Accessibility Survey

City of Downey Patton Road - Alameda Street To Stewart & Gray Road

Date of Inspection 4/2/2017

Prepared By **Disability Access Consultants**(800) 743-7067

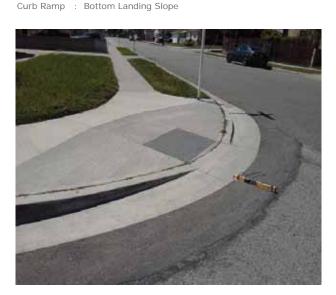
The bottom landing of the curb ramp is on the street, and the slope of the bottom landing is not compliant.

On-Site Finding 8.20 percent

Ensure the bottom landing slope is compliant and provides a smooth transition.

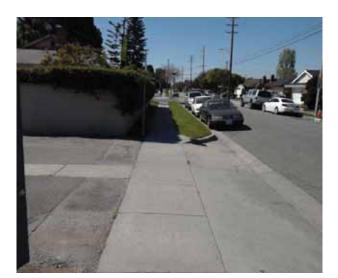
There are no detectable warnings where the pedestrian route crosses vehicular traffic.

On-Site Finding Not Found

Provide detectable warnings.

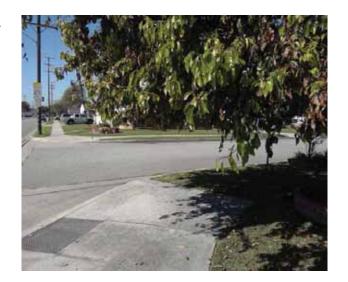
Overhead obstruction height is not compliant.

On-Site Finding 66.00 inches

Provide a compliant vertical clearance height.

Change In Level South Of Firestone Boulevard @ 33.933092560730, - 118.130710422993

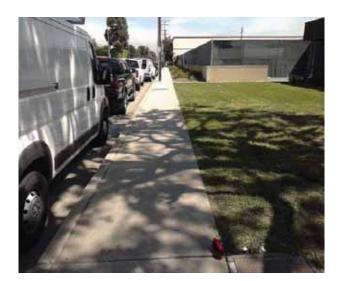
There is a change in elevation greater than recommended value.

On-Site Finding 0.62 inches

Ensure that the change in elevation is within the recommended value.

Change In Level South Of Firestone Boulevard @ 33.934561313396, - 118.129628151655

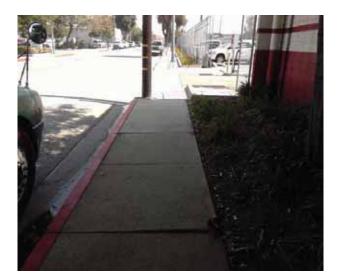
There is a change in elevation greater than recommended value.

On-Site Finding 0.87 inches

Ensure that the change in elevation is within the recommended value.

Change In Level South Of Firestone Boulevard @ 33.935956604963, - 118.128582090139

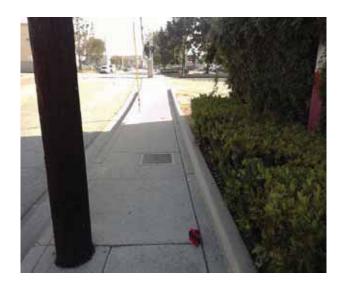
There is a change in elevation greater than recommended value.

On-Site Finding 0.62 inches

Ensure that the change in elevation is within the recommended value.

Change In Level North Of Mantee Street @ 33.934239747743, -118.130073398352

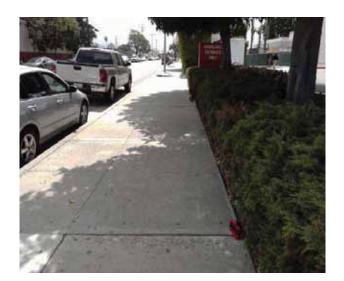
There is a change in elevation greater than recommended value.

On-Site Finding 0.75 inches

Ensure that the change in elevation is within the recommended value.

Change In Level North Of Mantee Street @ 33.934808328401, -118.129656314850

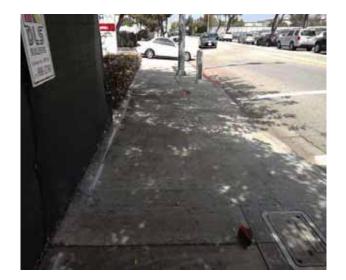
There is a change in elevation greater than recommended value.

On-Site Finding 0.50 inches

Ensure that the change in elevation is within the recommended value.

Change In Level North Of Mantee Street @ 33.936022252090, -118.128756433725

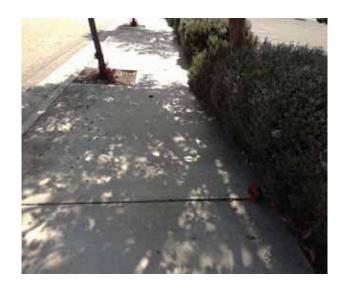
There is a change in elevation greater than recommended value.

On-Site Finding 0.50 inches

Ensure that the change in elevation is within the recommended value.

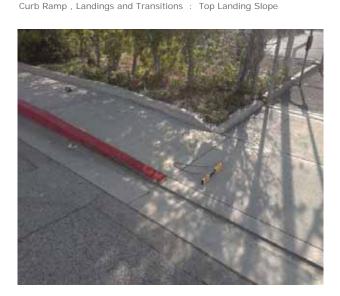
The slope at the top landing is greater than allowed.

On-Site Finding 2.80 percent

Provide a top landing surface that does not exceed the maximum slope and cross slope. Provide a sufficient maneuvering clearance that does not accumulate water.

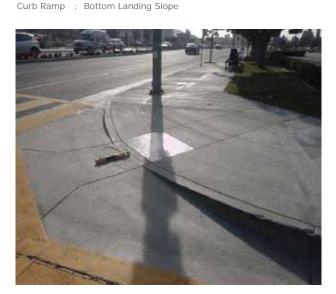
The bottom landing of the curb ramp is on the street, and the slope of the bottom landing is not compliant.

On-Site Finding 5.10 percent

Ensure the bottom landing slope is compliant and provides a smooth transition.

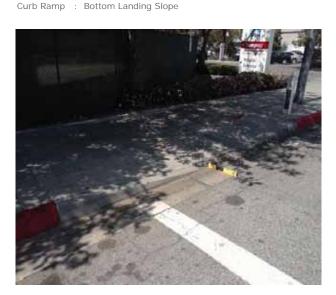
The bottom landing of the curb ramp is on the street, and the slope of the bottom landing is not compliant.

On-Site Finding 8.60 percent

Ensure the bottom landing slope is compliant and provides a smooth transition.

Change In Level South Of Firestone Boulevard @ 33.933987167642, - 118.130058646202

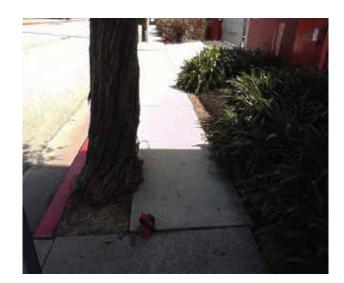
There is a change in elevation greater than recommended value.

On-Site Finding 0.62 inches

Ensure that the change in elevation is within the recommended value.

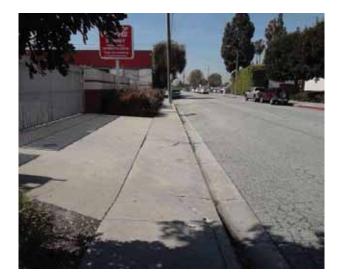
There are no detectable warnings where the pedestrian route crosses vehicular traffic.

On-Site Finding Not Found

Provide detectable warnings.

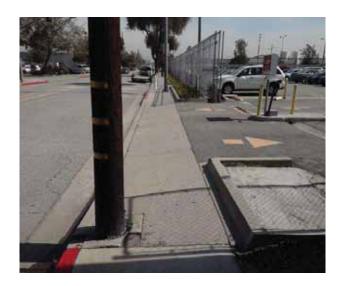
Sidewalk width at the obstruction is not compliant.

On-Site Finding 45.00 inches

Sidewalk width at the obstruction shall have the recommended value.

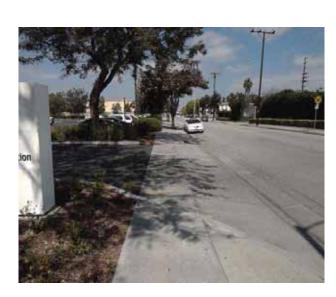
There are no detectable warnings where the pedestrian route crosses vehicular traffic.

On-Site Finding Not Found

Provide detectable warnings.

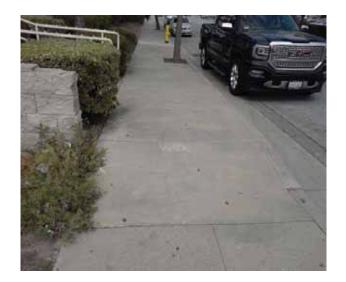
Sidewalk running slope is not compliant.

On-Site Finding 8.80 percent for 4.00 feet

Repave the sidewalk surface with the recommended running slope.

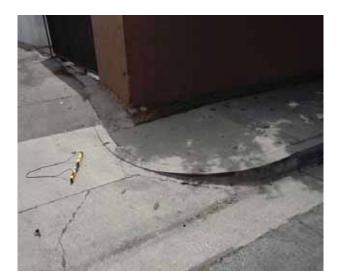
The slope at the top landing is greater than allowed.

On-Site Finding 3.10 percent

Provide a top landing surface that does not exceed the maximum slope and cross slope. Provide a sufficient maneuvering clearance that does not accumulate water.

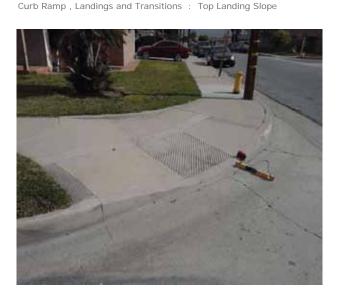
The slope at the top landing is greater than allowed.

On-Site Finding 5.00 percent

Provide a top landing surface that does not exceed the maximum slope and cross slope. Provide a sufficient maneuvering clearance that does not accumulate water.

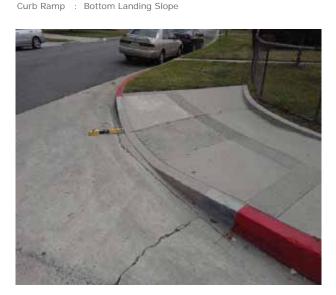
The bottom landing of the curb ramp is on the street, and the slope of the bottom landing is not compliant.

On-Site Finding 9.00 percent

Ensure the bottom landing slope is compliant and provides a smooth transition.

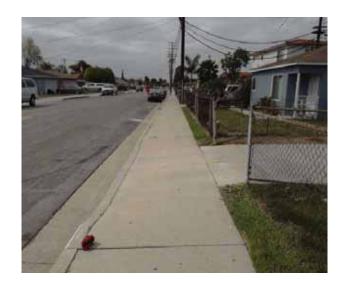
There is a change in elevation greater than recommended value.

On-Site Finding 0.37 inches

Ensure that the change in elevation is within the recommended value.

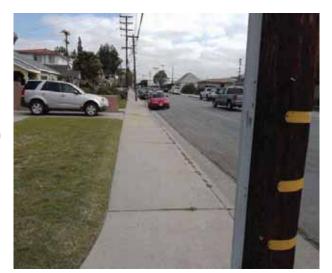
Ground surface has an opening that is not compliant.

On-Site Finding Not Compliant

Make sure that the surface opening does not allow passage of a sphere more than $\frac{1}{2}$ inch in diameter.

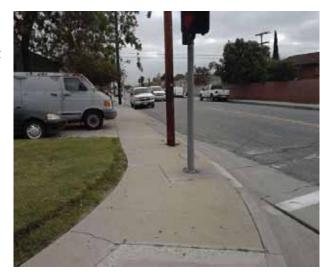
Sidewalk cross slope is not compliant.

On-Site Finding 3.50 percent for 100.00 feet

Repave the sidewalk surface with the recommended cross slope.
